Amendments to the Drawings:

REMARKS

FIG. 20

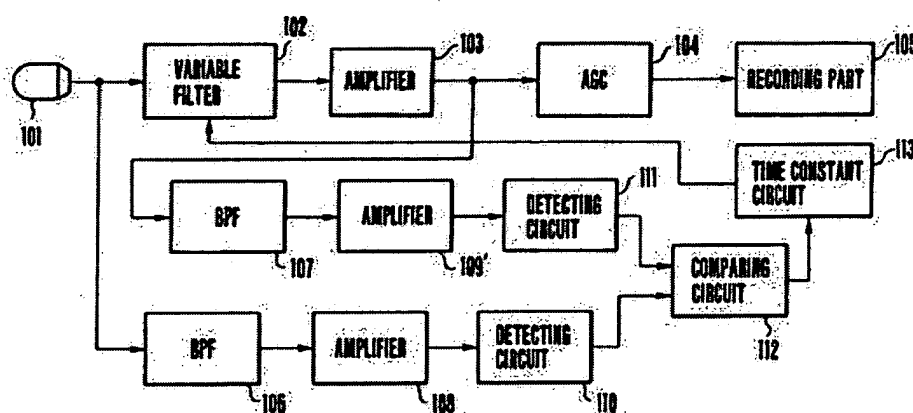
stage for providing as a comparison signal a comparison of an input signal. Furthermore, Hori cannot be viewed as having both a feedback signal that is compared to an input signal and an output of a comparison stage to which a tracking filter is responsive. Cited Figure 20 in Hori is reproduced below for the convenience of the Examiner. It will be appreciated that Hori is directed to reduction of low frequency noise signals generated in microphones. Hori teaches a microphone input that is separated into low and middle frequency components by band-pass filters 106 and 107. The levels of high and low components provided by corresponding detectors 110 and 111 are compared in comparing circuit 112 which generates a signal for controlling the slope (see fig. 17) or cutoff frequency (see fig. 18) of variable filter 102 (col. 10, line 64 - col. 11, line 25).

The Office Action suggests that an input to Hori's variable filter 102 teaches a feedback signal (Office Action at page 2, item 3). However, Hori cannot be said to teach the required the feedback signal *that is compared with an input signal in a comparison stage* required in claim 46. In Fig. 20 of Hori one input to variable filter 102 is an input from microphone 101 and cited in the Office Action as teaching the input of claim 46; the other input is received from a comparing circuit 112 through time constant circuit 113 and it is clear from Fig. 20 and from descriptions of variable filter 102 in Hori that this latter signal is not compared to the input signal from the microphone 101 (see Fig. 20 and col. 9 lines 2-22 and 47-53). Therefore, the signal

connecting constant circuit 113 and variable filter 102 in Fig. 20 cannot be construed as a feedback signal. Therefore, Hori cannot be said to teach or suggest a feedback signal and, more particularly, Hori cannot be said to teach a feedback signal that is compared with an input signal in the comparison stage as required by claim 46.

No other candidates for the recited feedback signal are taught in Hori. Hori's comparing circuit 112 compares mid-frequency and low-frequency bands of an input signal from microphone 101 (col. 9, lines 54-57). Applicant observes that the connection between amplifier 103 and band pass filter 107 cannot be construed as a feedback signal because "[a]s shown in FIG. 20, the mid-frequency component in the audio signal *which is not varied* in frequency characteristic by the variable filter 102 *is extracted by the BPF 107* from the audio signal amplified by the amplifier 103. (Hori at col. 11, lines 57-60). Thus, in Hori, the signal path that includes band pass filter 107, amplifier 109' and detecting circuit 111 passes only mid-frequency band components of the signal that are used to control filtering of low-frequency band components through variable filter 102. Therefore, no feedback path or signal exists in Hori.

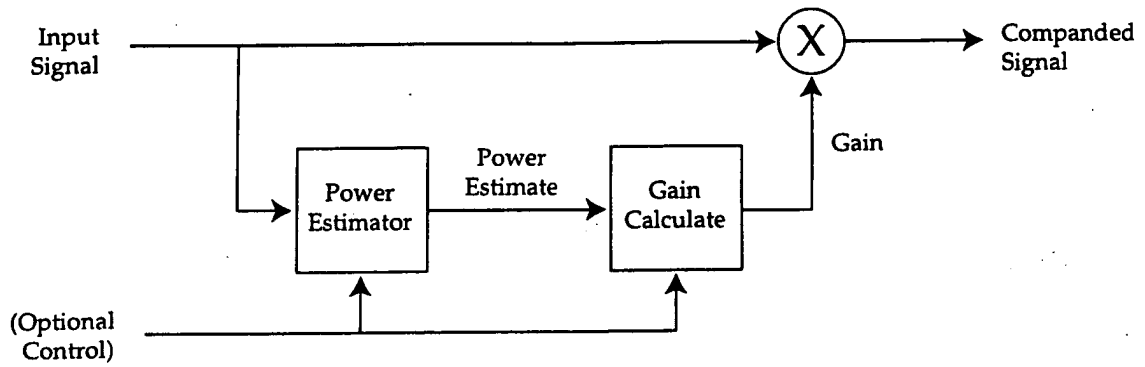
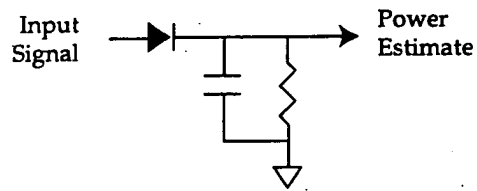
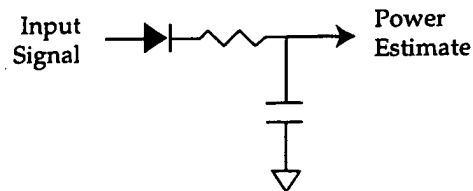
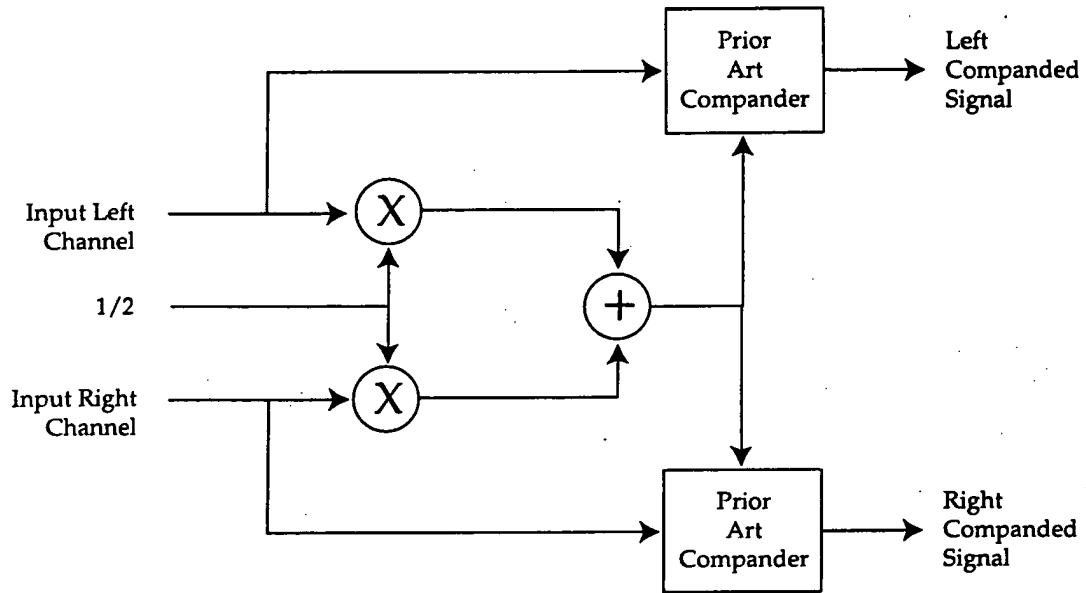
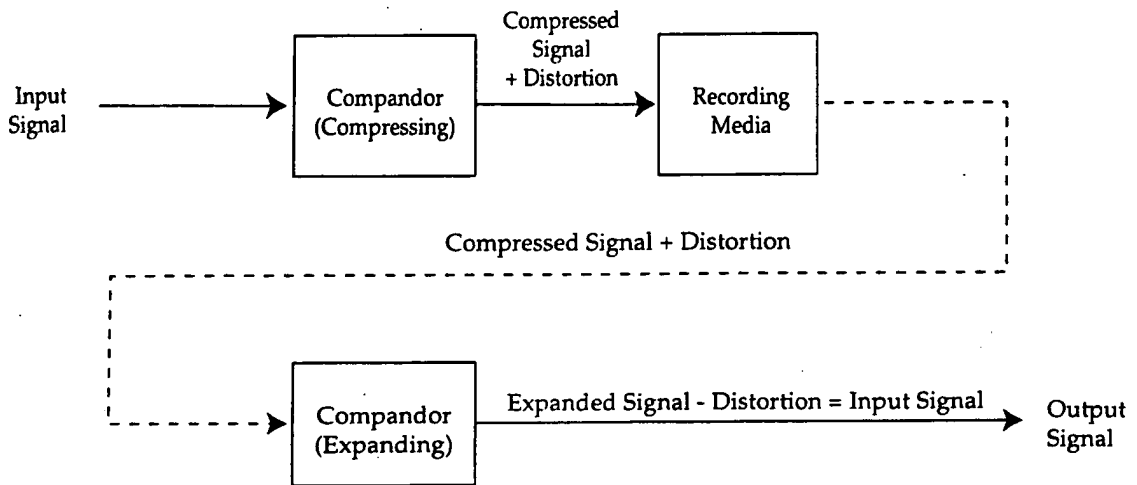
The Office Action objects to the drawing sheets 1 and 2 as requiring legends identifying Figures 1A-1E as prior art. In this Amendment, Applicant provides corrected drawings in compliance with 37 C.F.R. 1.84(c) as required by the Examiner.

The attached sheets of drawings include changes to Figs. 1A to 1E. These sheets which include Figs. 1A to 1C and Figs. 1D to 1E, respectively, replace the original sheets including Figs. 1A to 1C and Figs. 1D to 1E, respectively. The term “Prior Art” has been added to each sheet of drawings.
